**FINAL ENVIRONMENTAL IMPACT STATEMENT
FOR AUTHORIZATION FOR INCIDENTAL TAKE
AND IMPLEMENTATION
OF THE STANFORD UNIVERSITY
HABITAT CONSERVATION PLAN**

VOLUME II: COMMENTS AND RESPONSES

**U.S. Fish and Wildlife
Service**

**National Marine Fisheries
Service**

Scale 1:30,000  **Figure 6.1**
 0 0.5 1 Miles

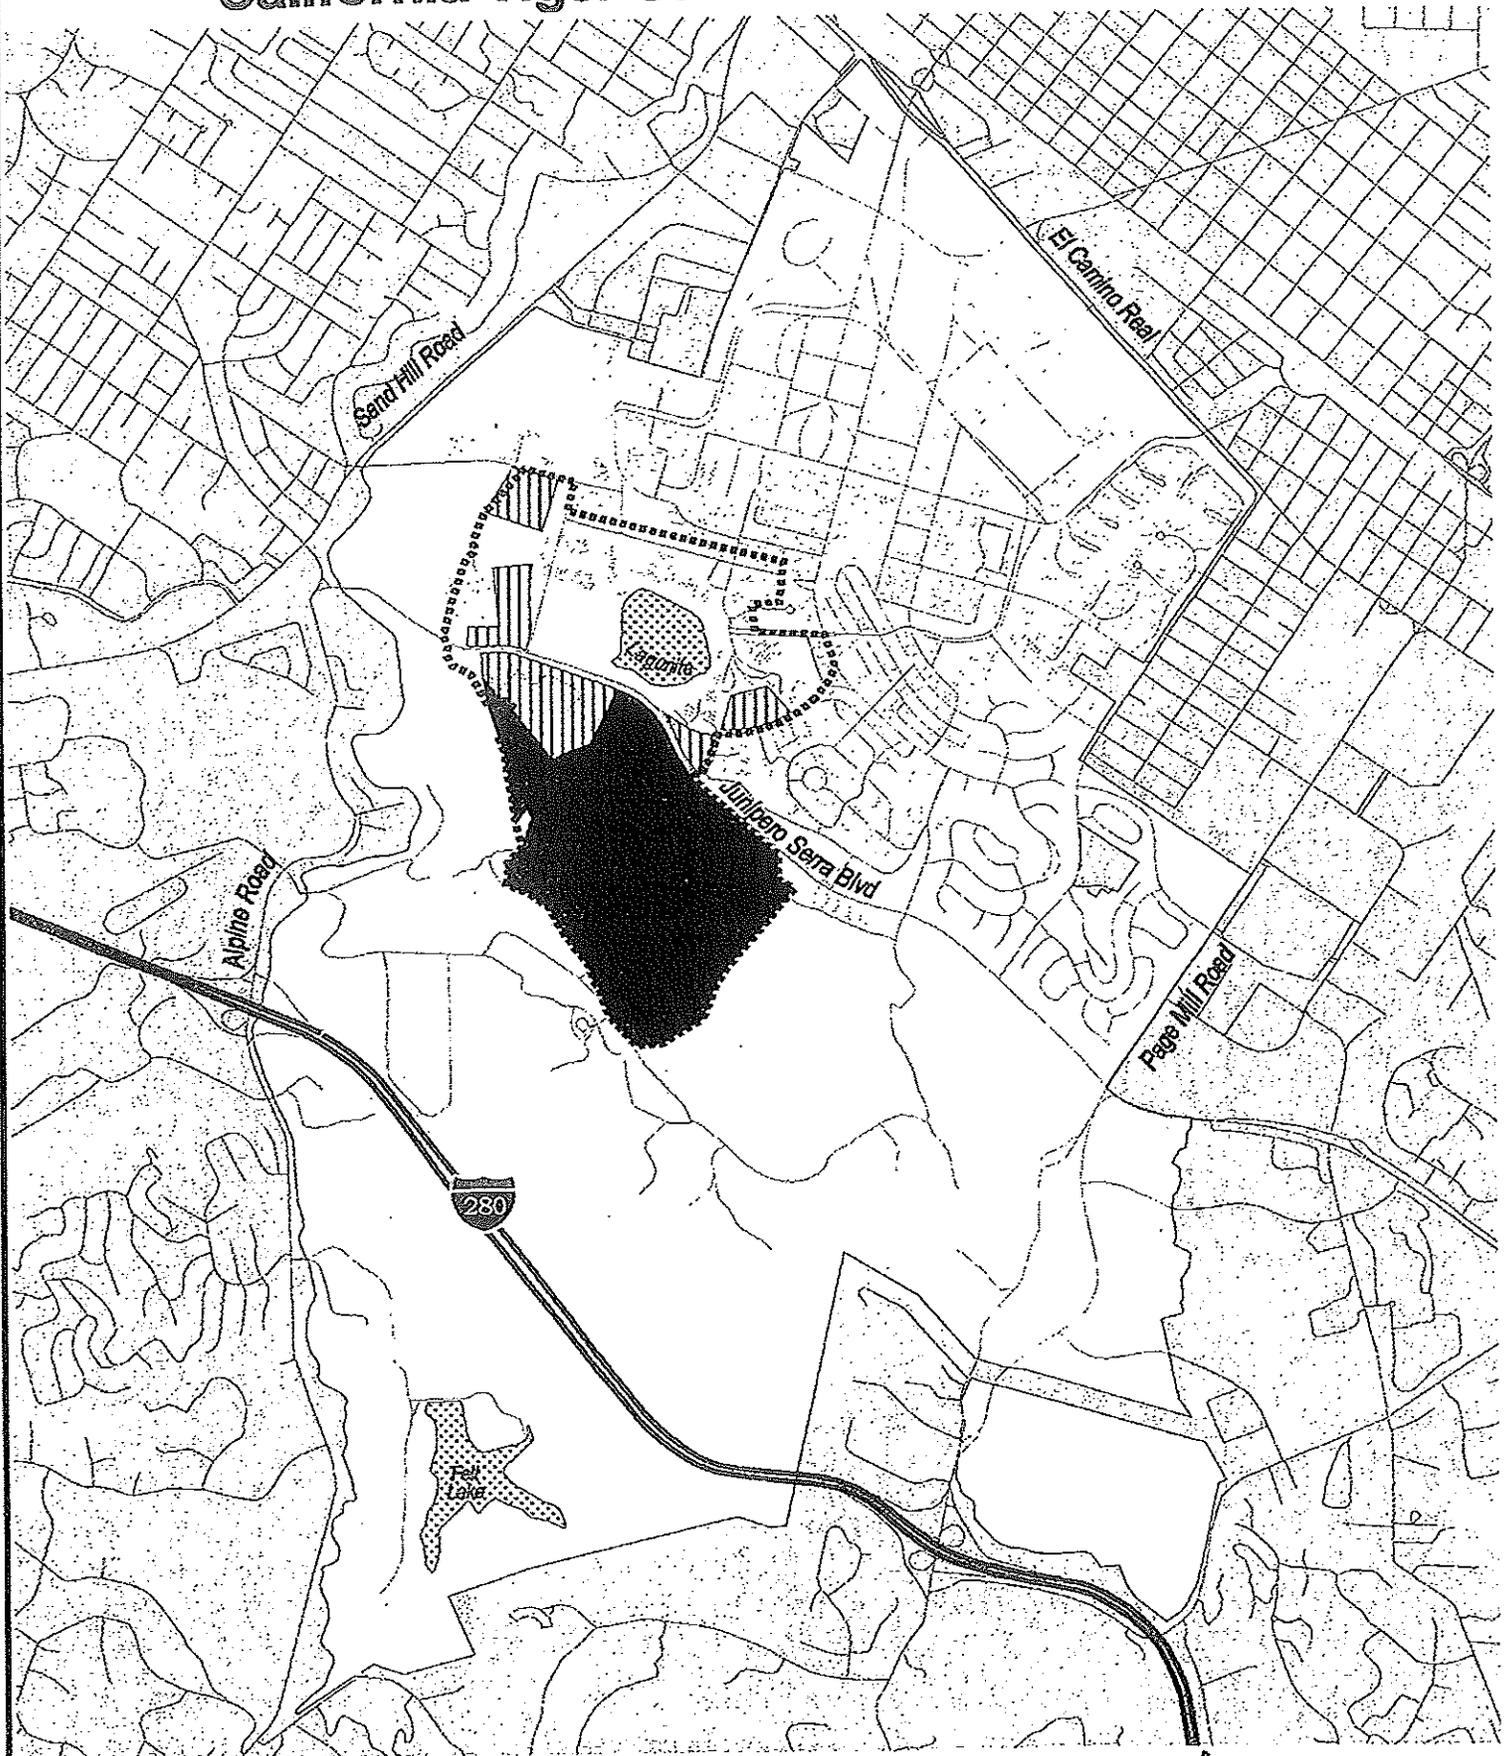
Map (SCP Figure 6.1, Attachment B). There are several SCP policies ensuring protection of habitat, monitoring requirements, and an implementing measure that requires "long-term habitat protection measures in appropriate locations as mitigation for development..." The supporting text states: "the primary tools to protect prime habitat are long-term conservation easements and creation of new salamander habitat through the addition of new viable breeding ponds."
